Contract No. T200411209.01
Federal Aid Project No. ESTP-S028(8)
SR 24, Mulberry Knoll to SR 1
Sussex County

Enclosed is Addendum No. 1 for the referenced contract consisting of the following:

Addendum No. 1
October 24, 2019

SECTION	SHEET NO.
AEC	15

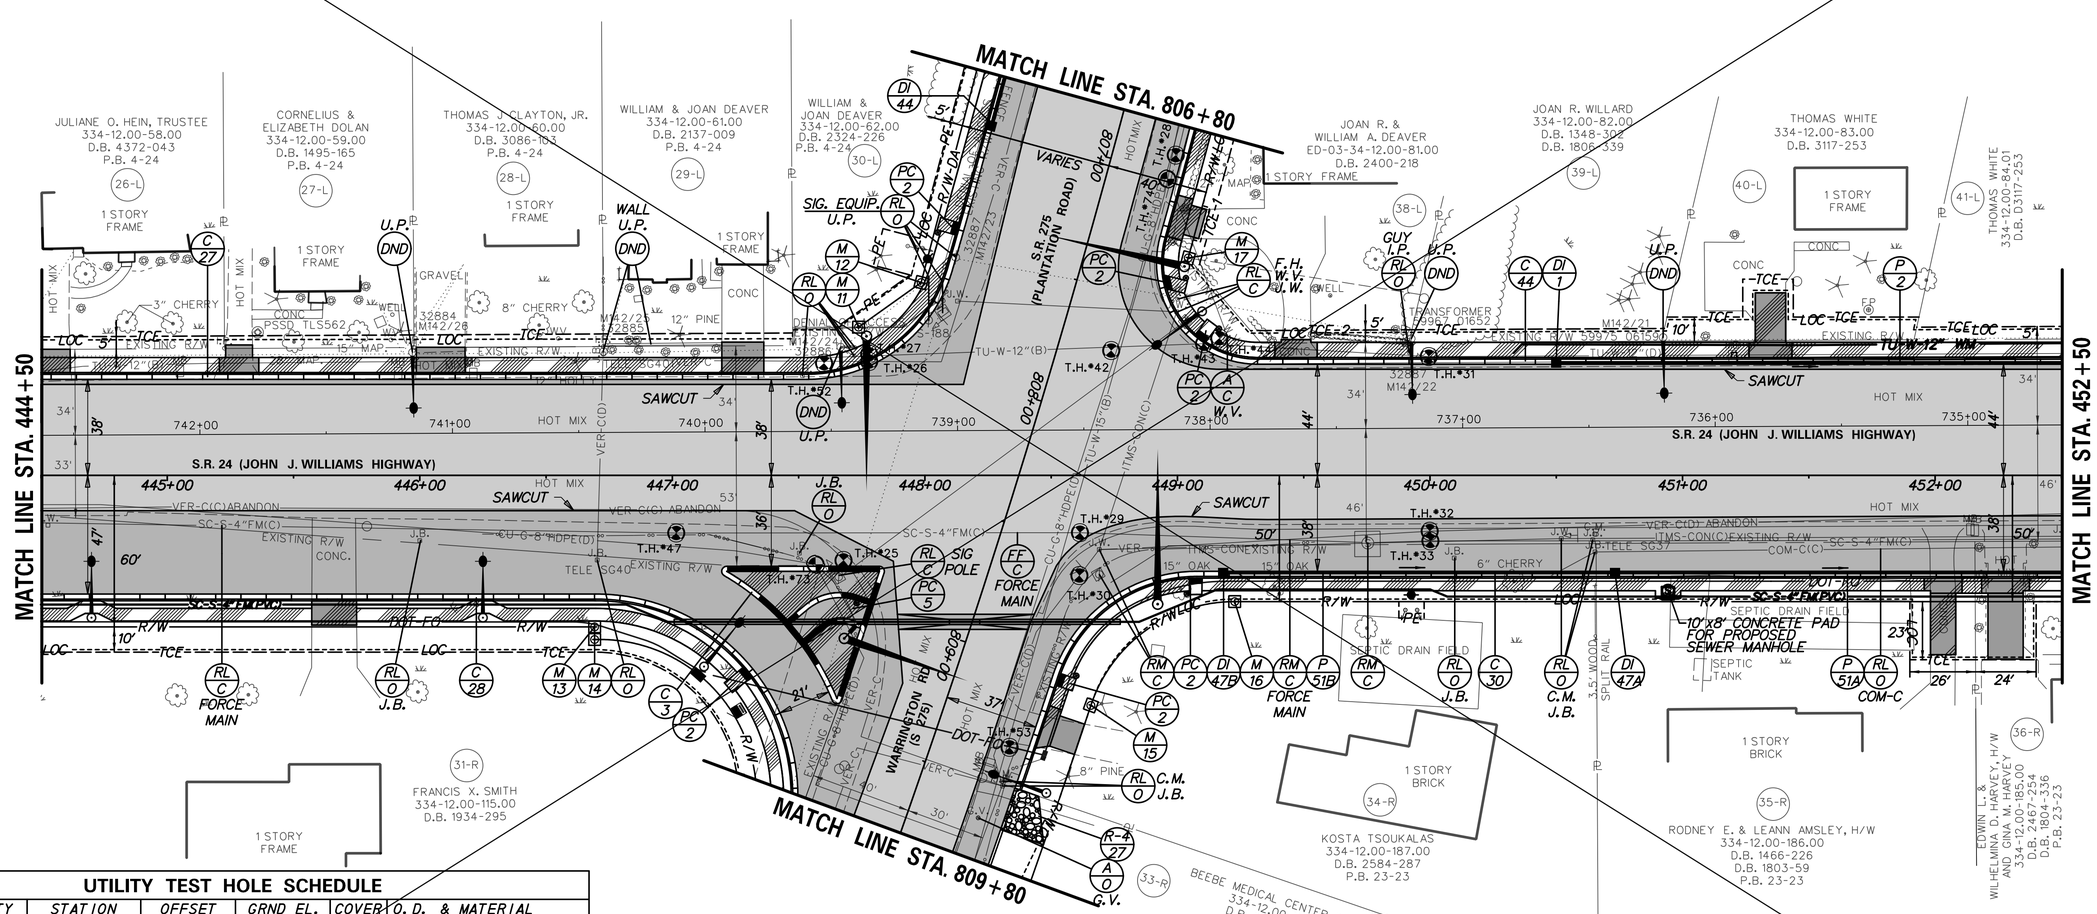
1 REVISED SIDEWALK WIDTH FROM 6' TO 5' FROM STA 449+10 TO STA 451+30 LT — D. SEMPLE 10/03/2019

SECTION	SHEET NO.
AEC	15A

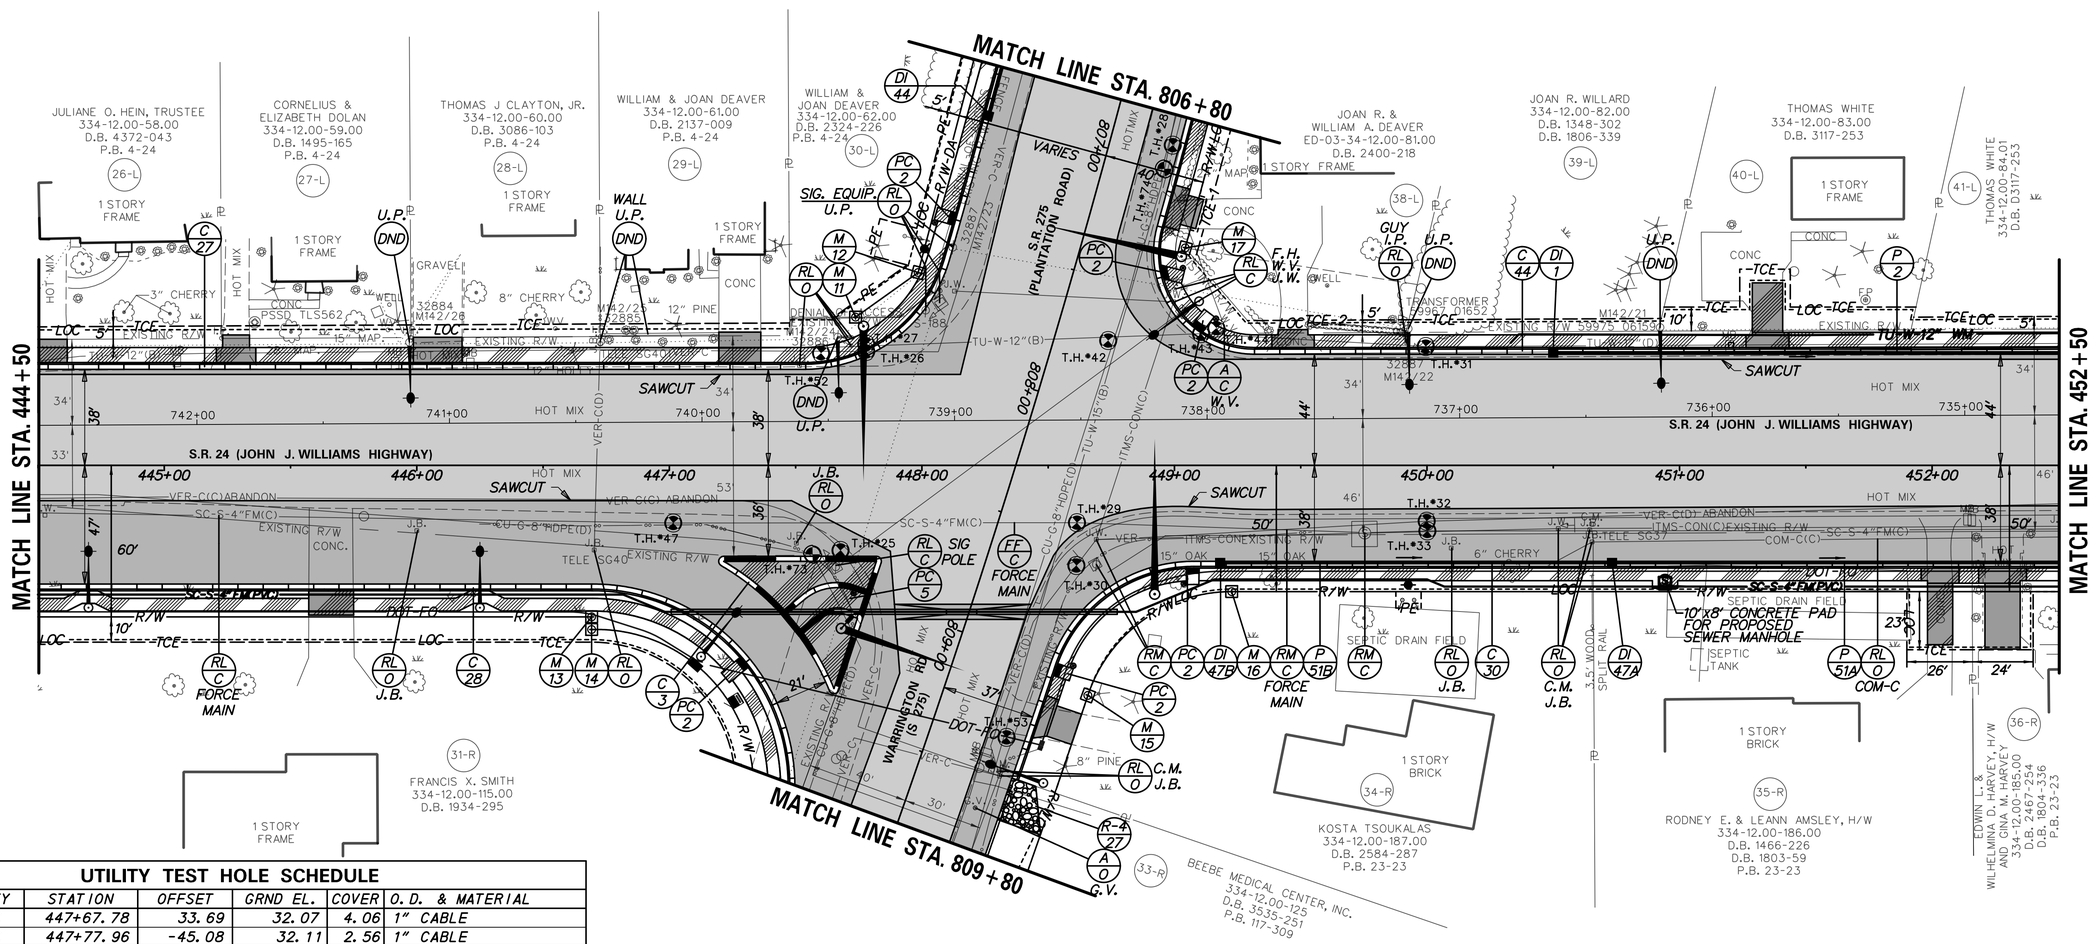
1 REVISED SIDEWALK WIDTH FROM 6' TO 5' FROM STA 449+10 TO STA 451+30 LT — D. SEMPLE 10/03/2019

CP-04 | SECTION AEC | SHEET NO. 16

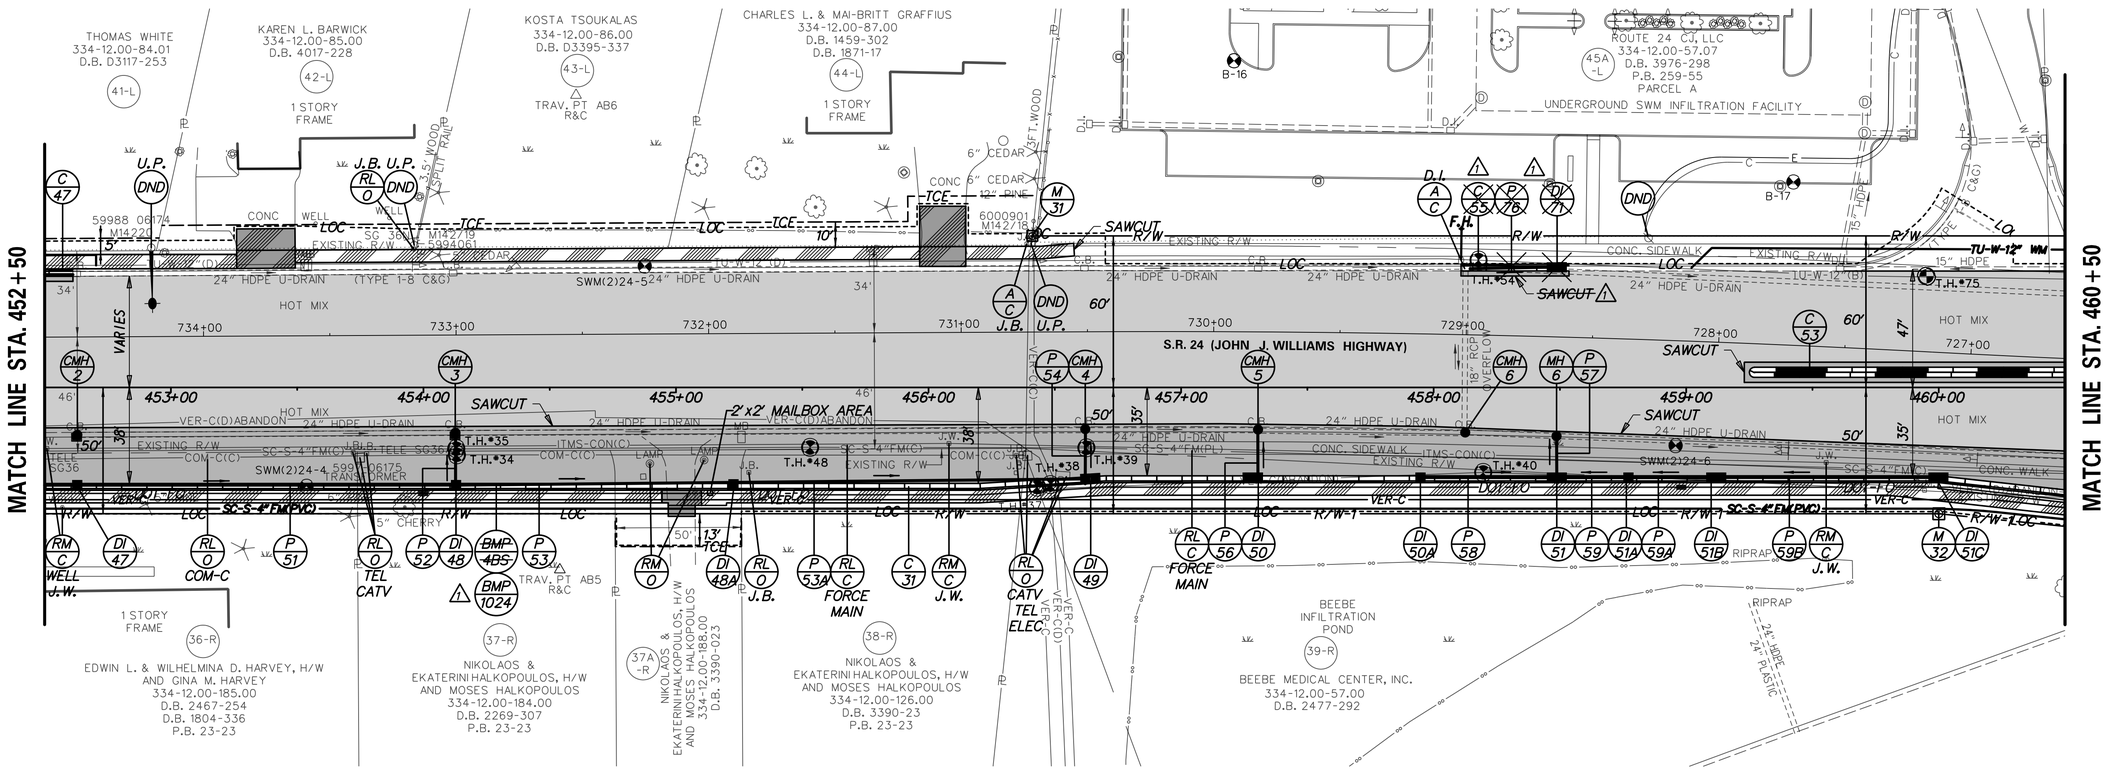
1 REVISED BMP NUMBERS AND DESCRIPTIONS; REMOVAL OF DRAINAGE AT 458+50 LT — D. SEMPLE 10/03/2019

CP-05
SECTION
AEC
SHEET NO.
17

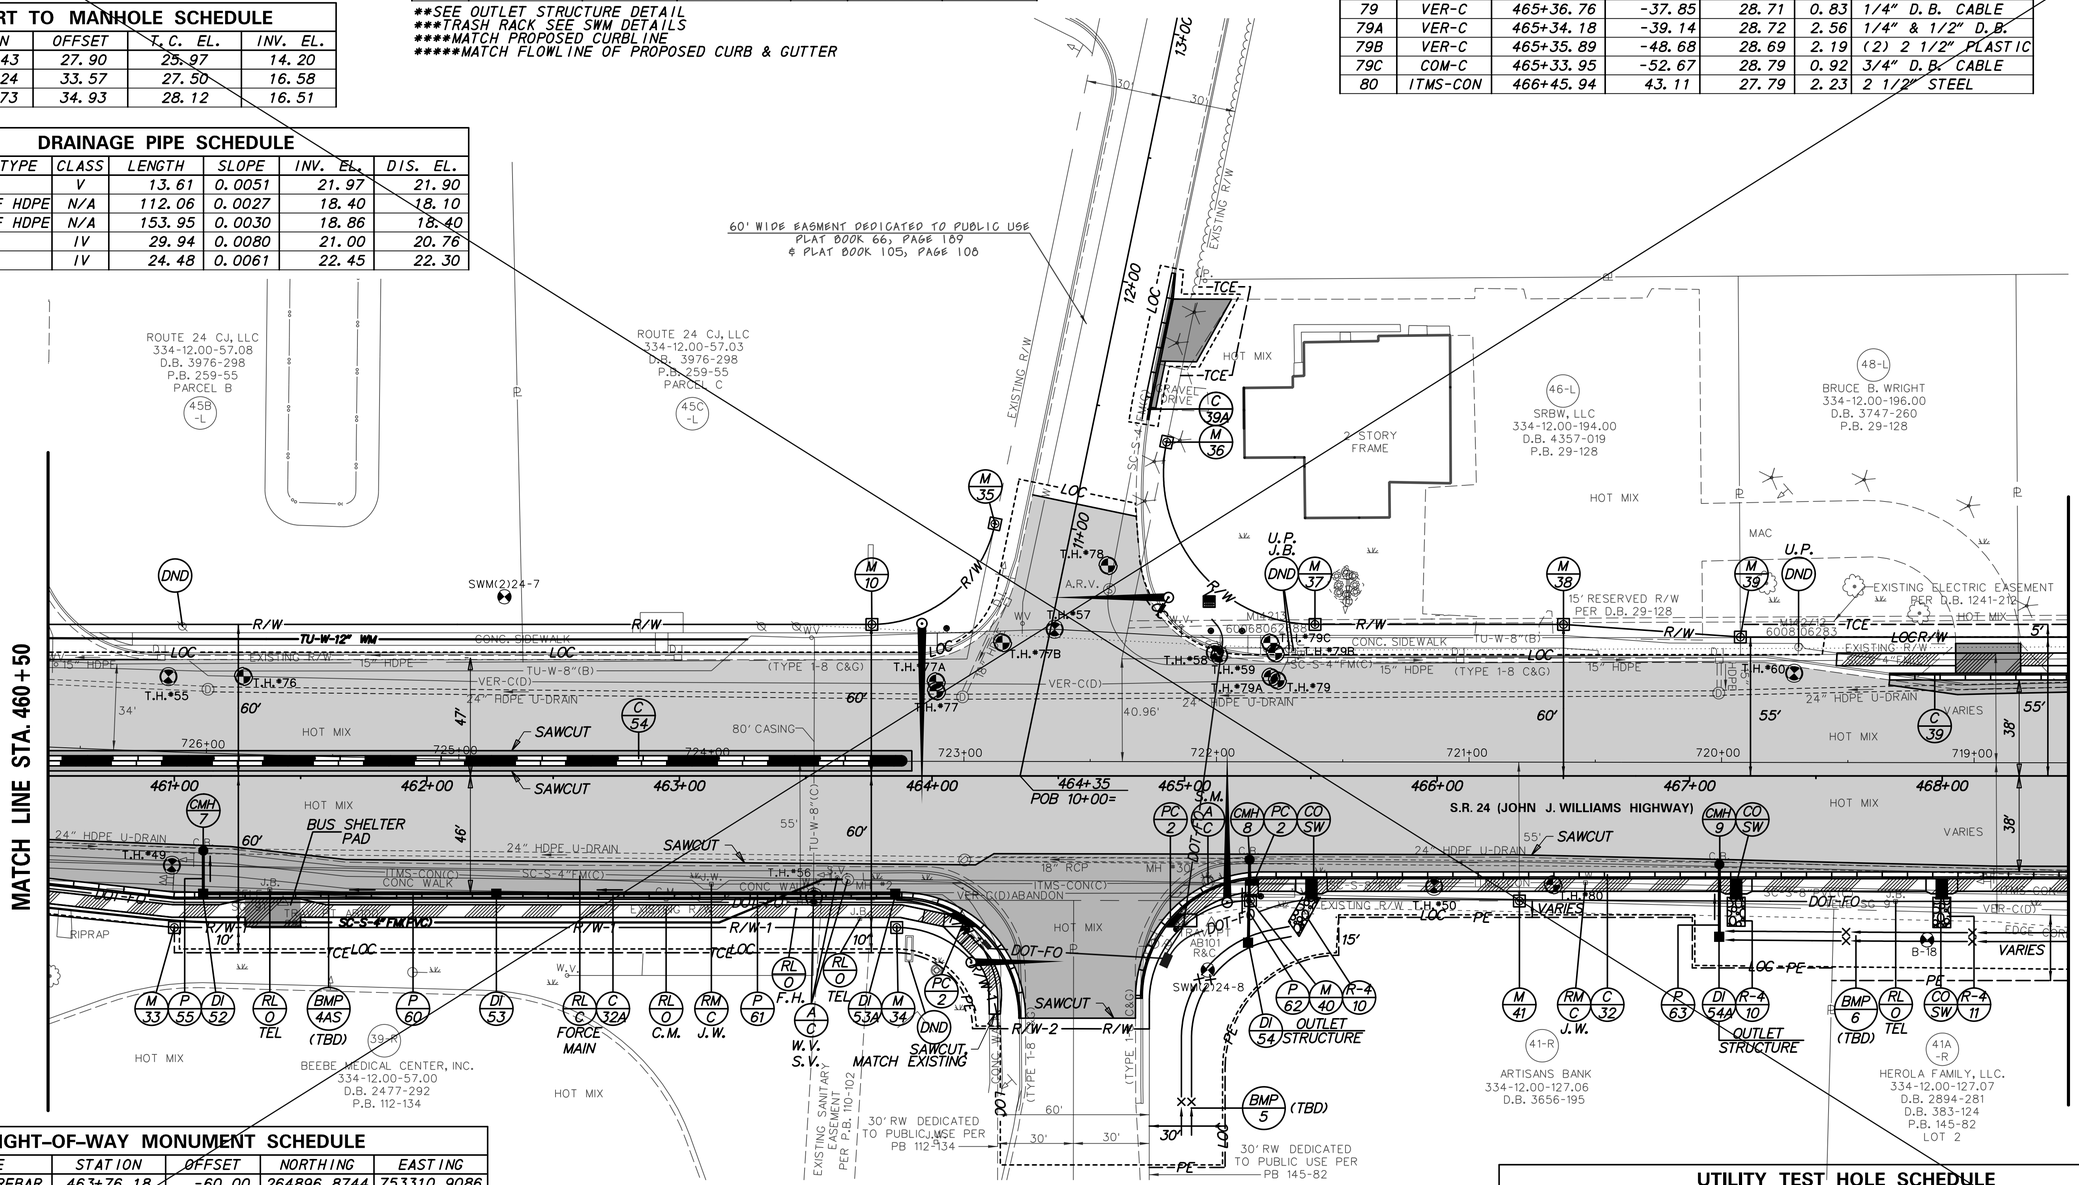
1 REVISED BMP NUMBERS AND DESCRIPTIONS; REVISED DRIVEWAY LAYOUTS — D. SEMPLE 10/03/2019

CP-05
SECTION
AEC
SHEET NO.
17A

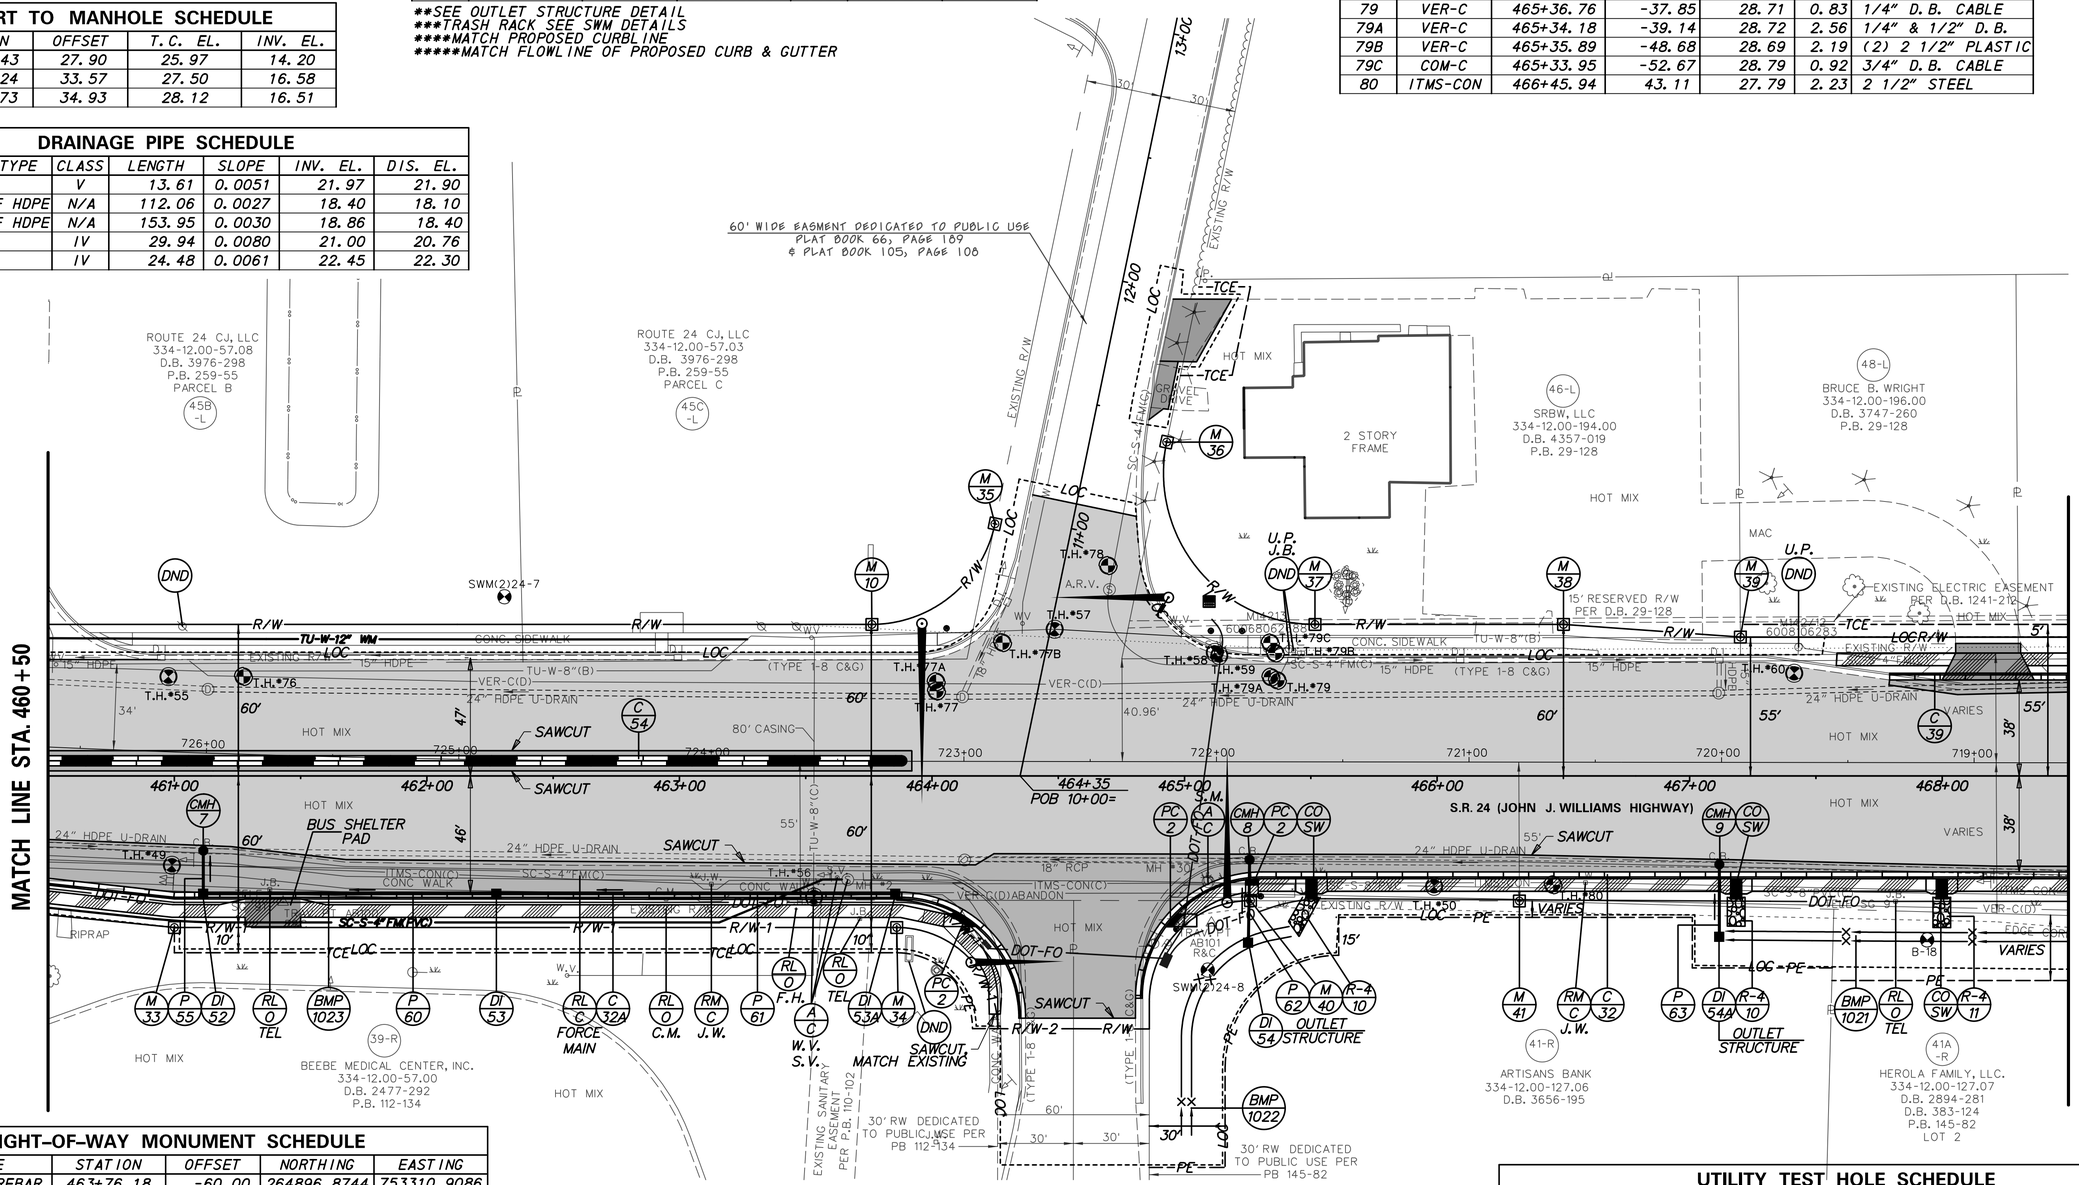
1 REVISED BMP NUMBERS AND DESCRIPTIONS; REVISED DRIVEWAY LAYOUTS — D. SEMPLE 10/03/2019
